Access Compliance Report

Public Rights-of-Way

(Curb Ramps)

Intersection ID: 2580	Main Street: BENTGRASS_RUN_DR	Cross Street: GREAT_BEAR_CT	Location: E
ADA ID: FF0DA03AE1DF	Ramp Type: PerpDiag	Initial Pass/Fail: Fail	Overall Compliance: No
Severity Score: 35			
Codes/Mitigation Info/Possible Solution		Field Measurements/Component Compliance

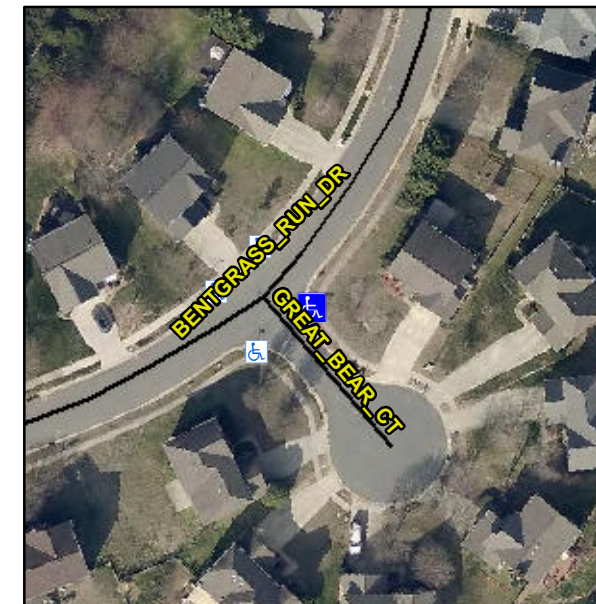
Not Found, R304.5.1, R304.2.2, R304.5.3

Compliance	Description	Data	Compliance	Description	Data
N/A	Ramp Length (in)	48.0	No	Ramp Slope (%)	12.4
No	Ramp Width (in)	47.5	No	Ramp XSlope (%)	4.6
N/A	Flare Type LT	N/A	N/A	Flare Type RT	N/A
N/A	Flare Slope LT (%)	N/A	N/A	Flare Slope RT (%)	N/A
N/A	Flare Traversable LT?	N/A	N/A	Flare Traversable RT?	N/A
N/A	Landing Length (in)	N/A	N/A	DWS Provided?	N/A
N/A	Landing Width (in)	N/A	N/A	DWS Contrast?	N/A
N/A	Landing Slope (%)	N/A	N/A	DWS Length (in)	N/A
N/A	Landing X Slope (%)	N/A	N/A	DWS Full Width?	N/A
N/A	Landing Curb? (Y/N)	N/A	N/A	DWS Offset (in)	N/A
N/A	Shared Landing?	N/A			
N/A	Gutter Ponding?	N/A	N/A	Gutter Slope (%)	N/A
N/A	Gutter Lip Ht (in)	N/A	N/A	Gutter X Slope (%)	N/A
N/A	Painted X Walk1?	No	N/A	Painted X Walk2?	No
	X Walk 1 Direction	To NW		X Walk 2 Direction	To SW
N/A	X Walk 1 Width (in)	N/A	N/A	X Walk 2 Width (in)	N/A
	X Walk 1 Slope (%)	4.0		X Walk 2 Slope (%)	1.9
	X Walk 1 X Slope (%)	2.5		X Walk 2 X Slope (%)	2.7

Remove & Replace Curb Ramp With Two New Directional Ramps or Equivalent.
